NSW RURAL FIRE SERVICE COMMENTS - PLANNING PROPOSAL AMENDING THE KURING-GAI LEP TO REZONE SUBJECT SITE FROM R2 LOW DENSITY RESIDENTIAL TO R3 MEDIUM DENSITY RESIDENTIAL

Submission by NSW Rural Fire Service

NSW Department of Planning and Environment
Submission by NSW Rural Fire Service
Mark Sugden, A/Manager Development Planning & Policy
8 February 2023

Subject: RE: PP-2022-658_Stanhope Road, Killara - Issues for discussion-23 November 2023

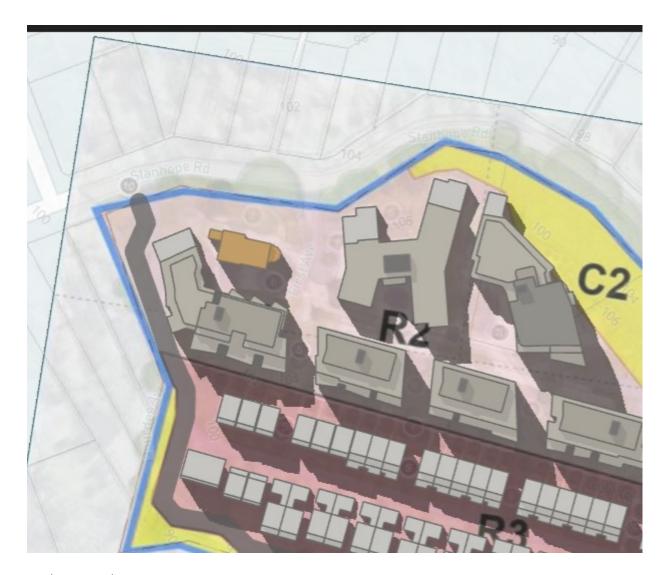
If I could seek some clarification around the perimeter road? Could you please provide some guidance on whether this could connect through the site to Stanhope Road at each end (as indicated in my rough plan below) or would it need to provide internal access to the northern portion of C2 land (between the building and C2 area)?

We need to understand if this is likely to impact the current FSR proposed on the site.

A perimeter road, such as what you have provided below, could be deemed an acceptable solution to the requirement.

However the proponent may wish to demonstrate that an alternate solution based on a performance based design may also meet the intent of a perimeter road.
